PLANS AND DOCUMENTS referred to in the PDA DEVELOPMENT APPROVAL

Approval no: DEV2020/1150/2

AMENDED IN RED

FLIPSIDE CIRCUS NORTHSHORE

1 E-03 WEST ELEVATION
1:125

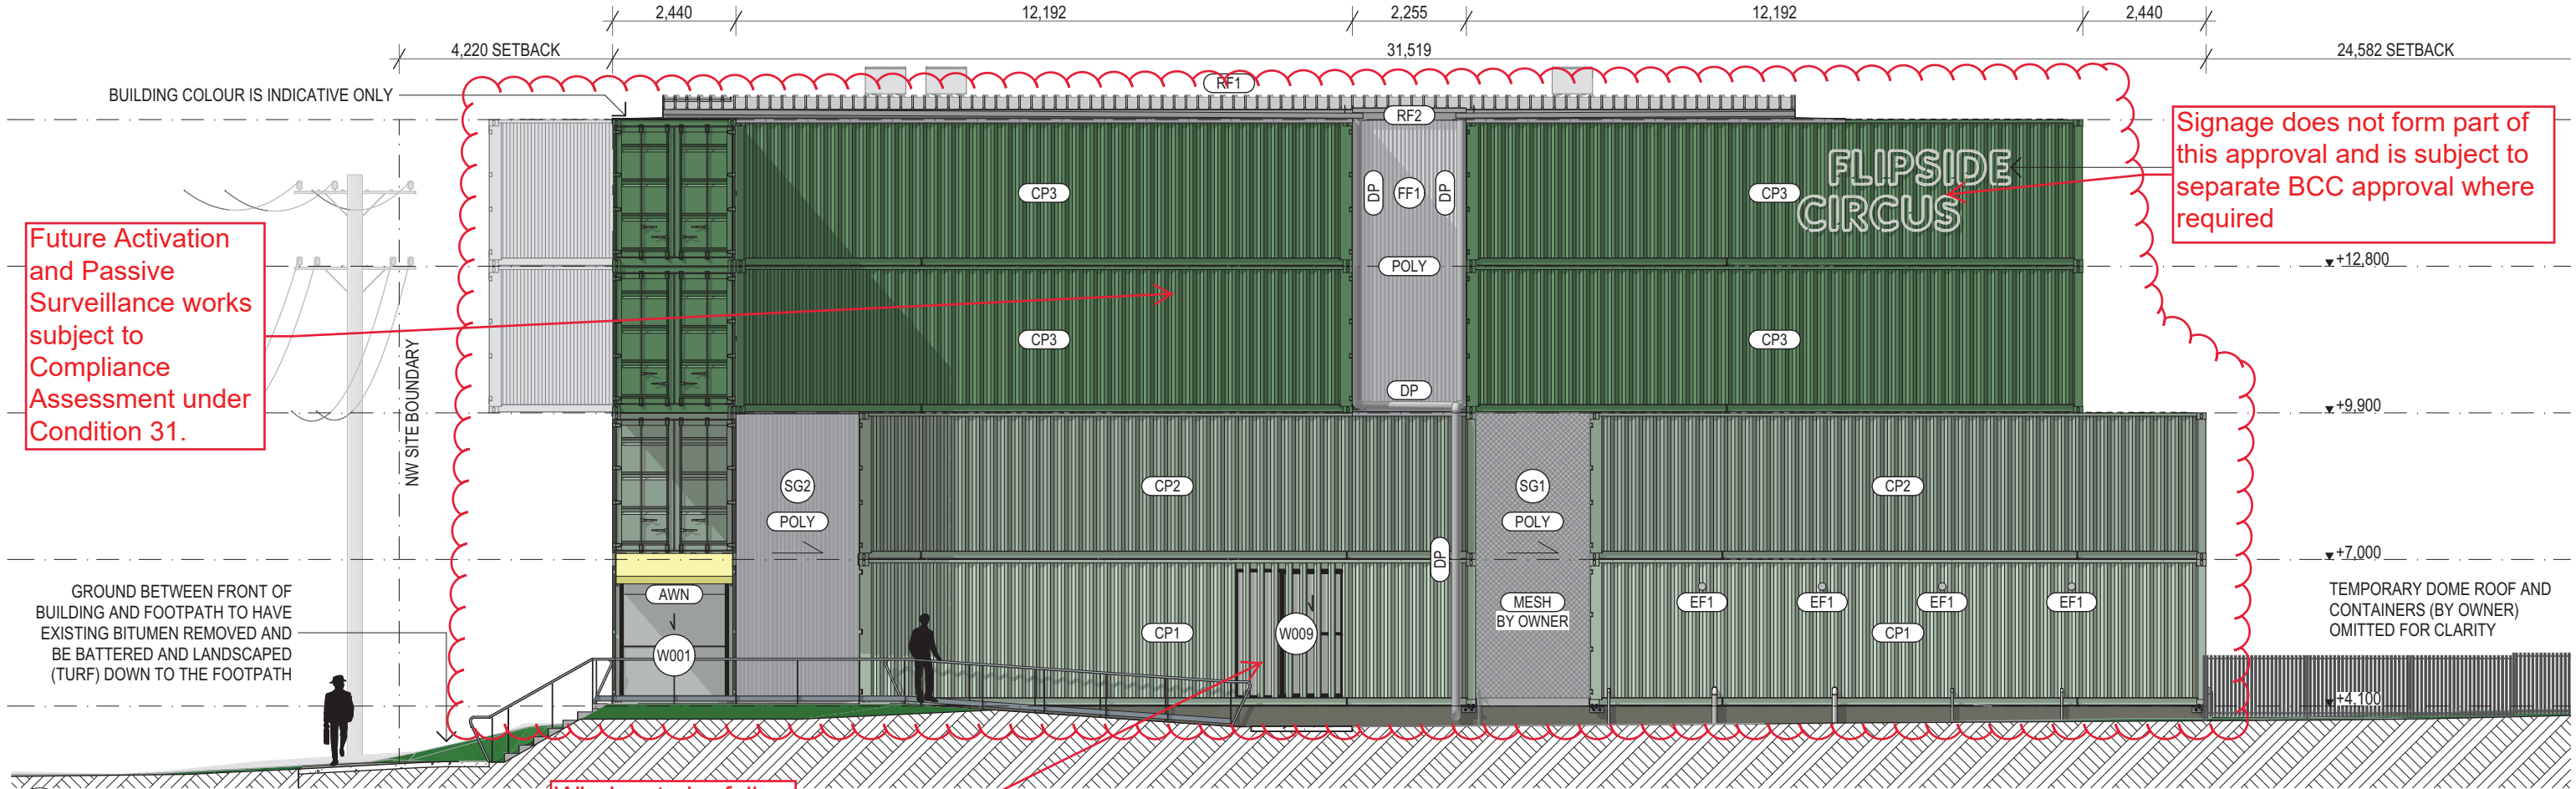
Future Activation and Passive Surveillance works subject to Compliance Assessment under Condition 31.

Signage does not form part of this approval and is subject to separate BCC approval where required

Window to be fully transparent and free from obstructions (E.g. the bars currently shown)

2 E-04 EAST ELEVATION
1:125

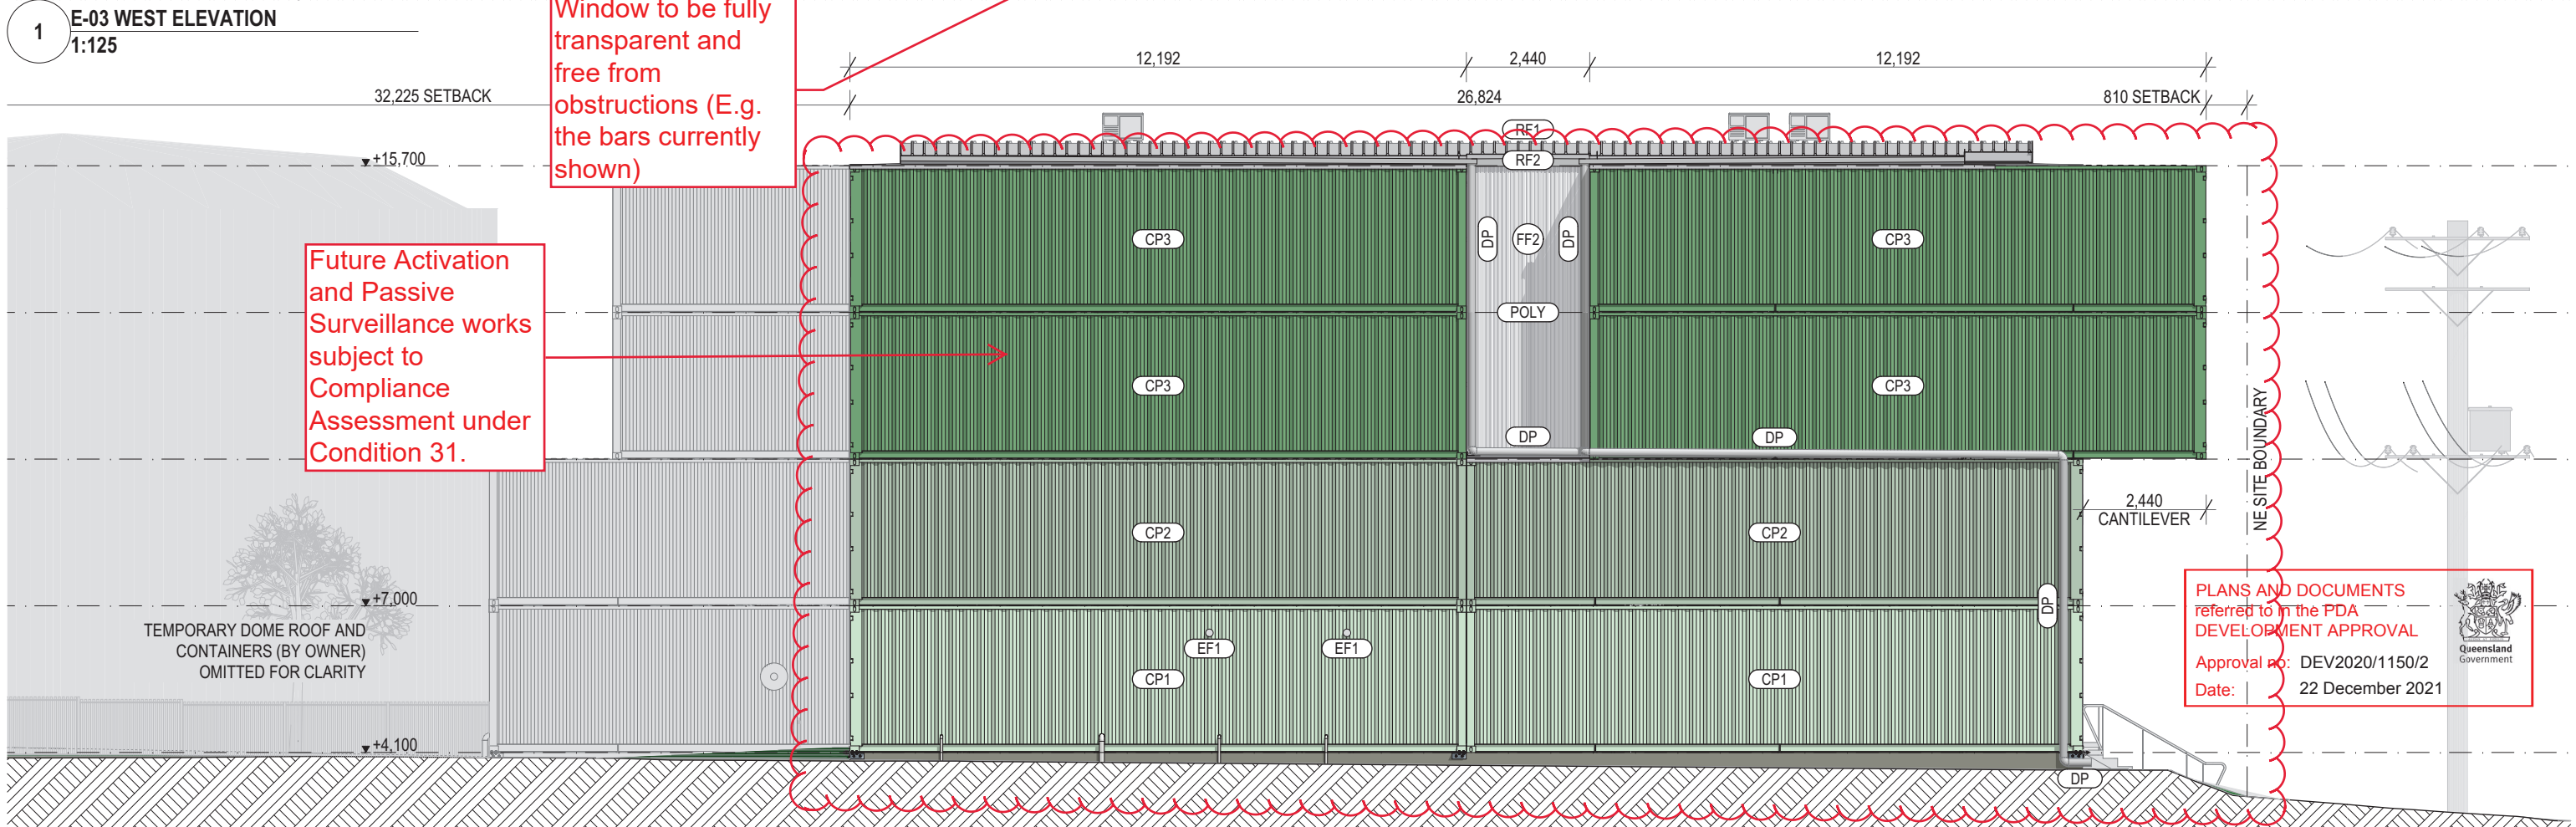
Future Activation and Passive Surveillance works subject to Compliance Assessment under Condition 31.

END OF TRIP / NLA PLAN
1:150

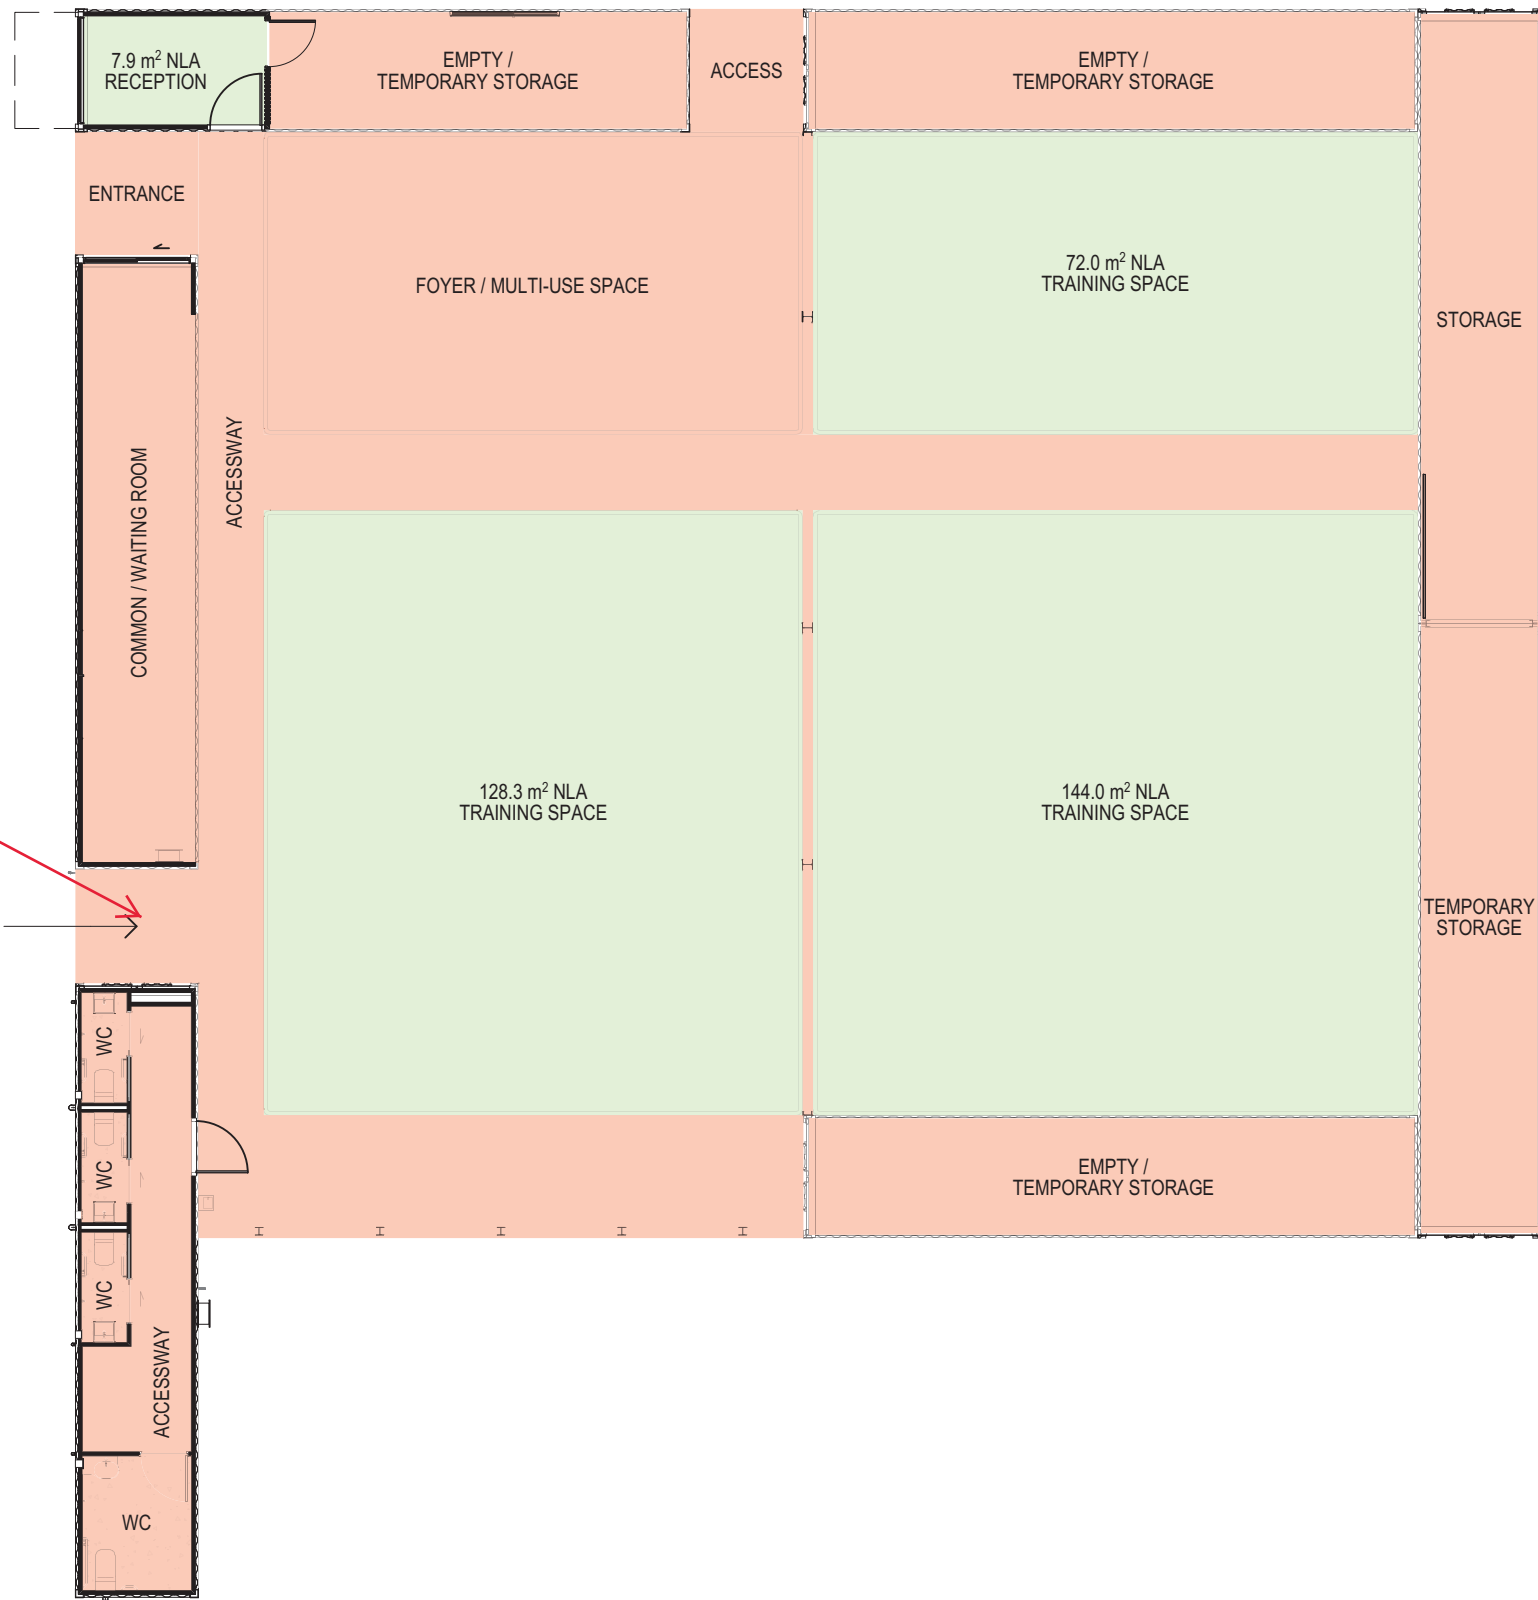
Bicycle parking to be provided in Stage 1 in accordance with approved plan 'End of Trip Plan - Stage 2' prepared by Blok (Drawing 2003, Issue DD16, dated 1 December 2021 (Amended in Red 13 December 2021))

1 END OF TRIP / NLA PLAN
1:150

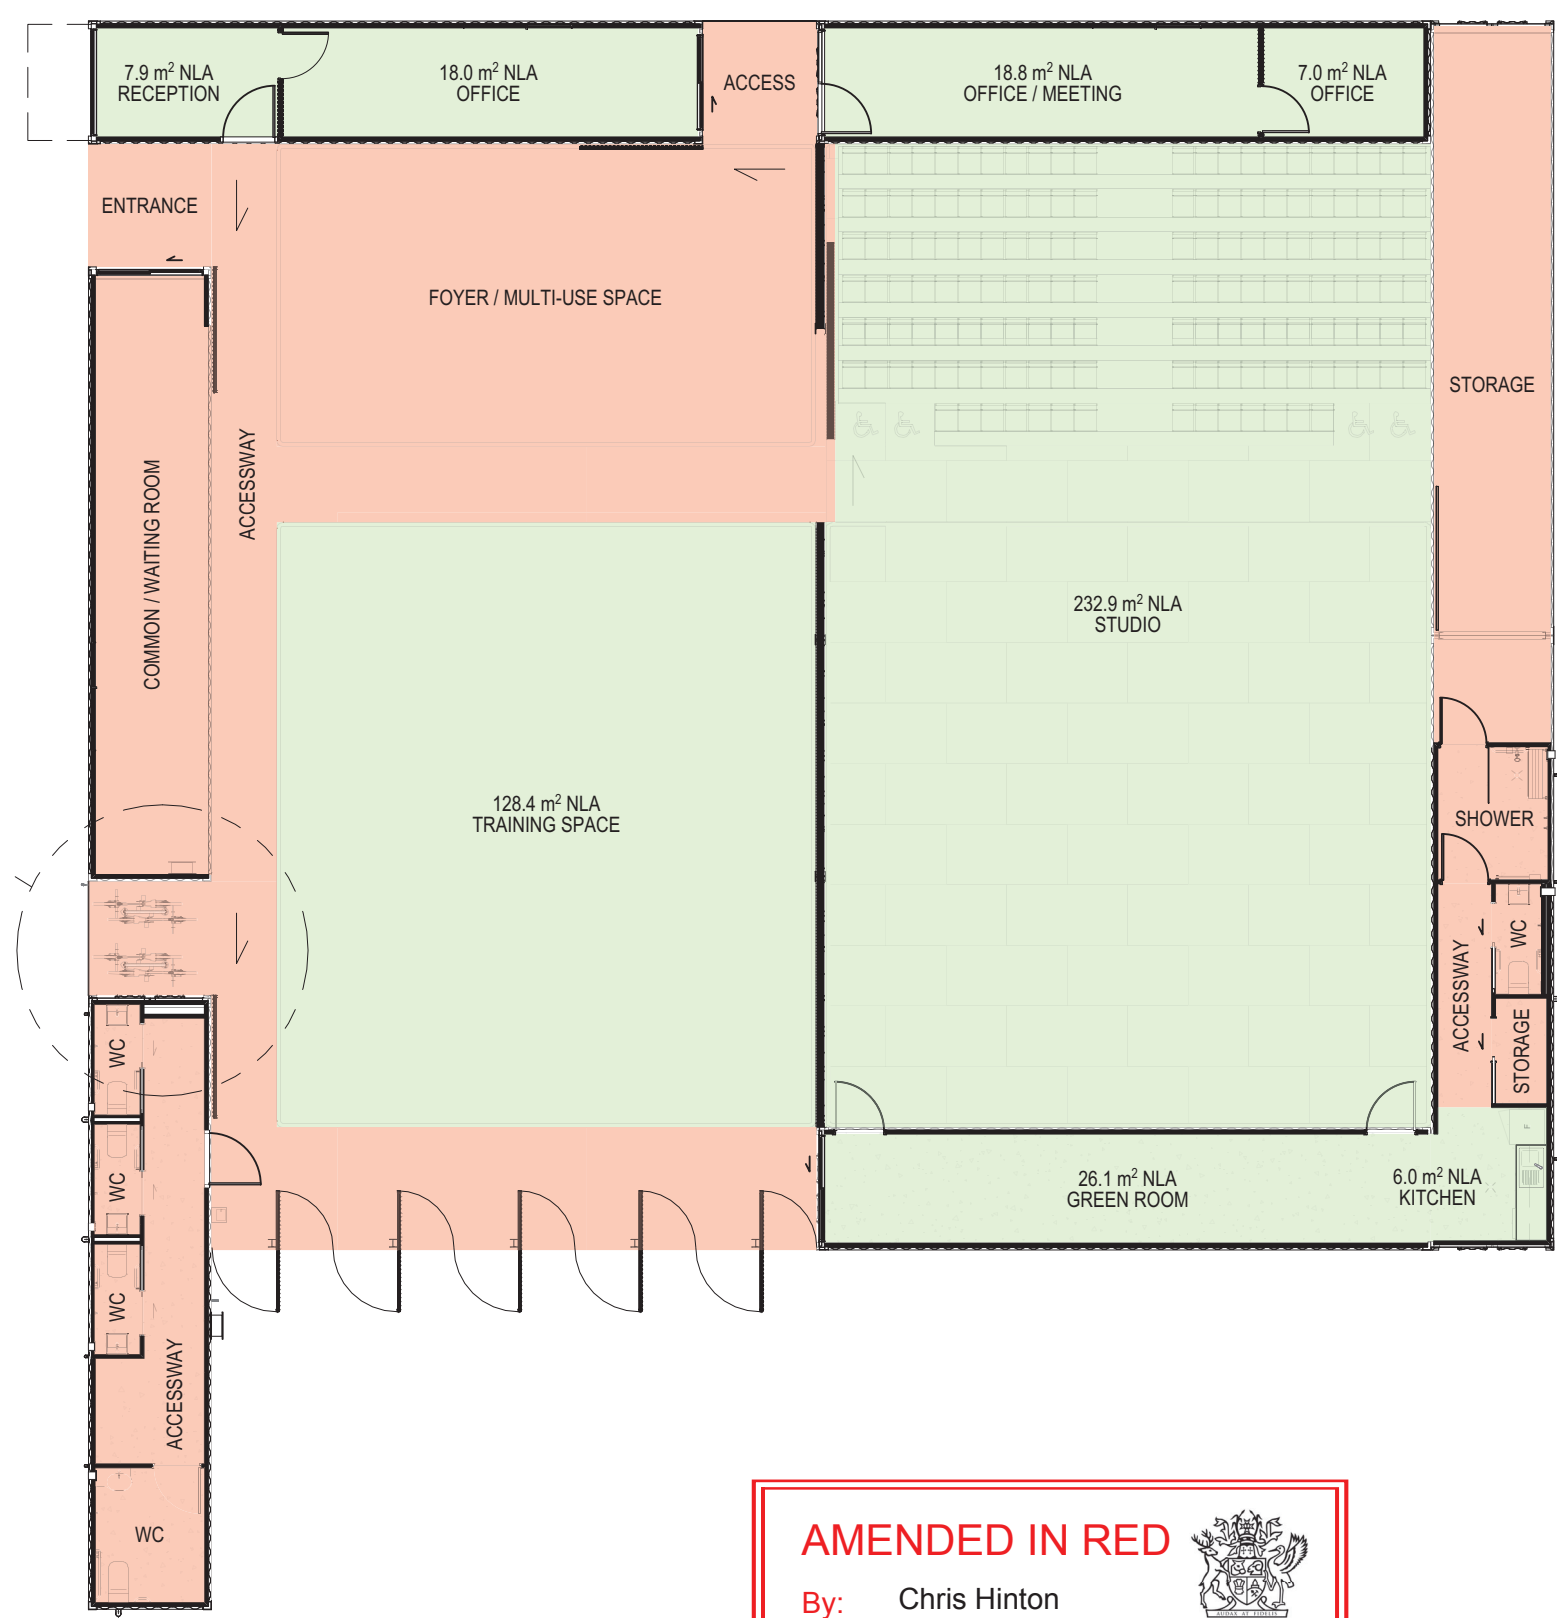
To be delivered in Stage 1
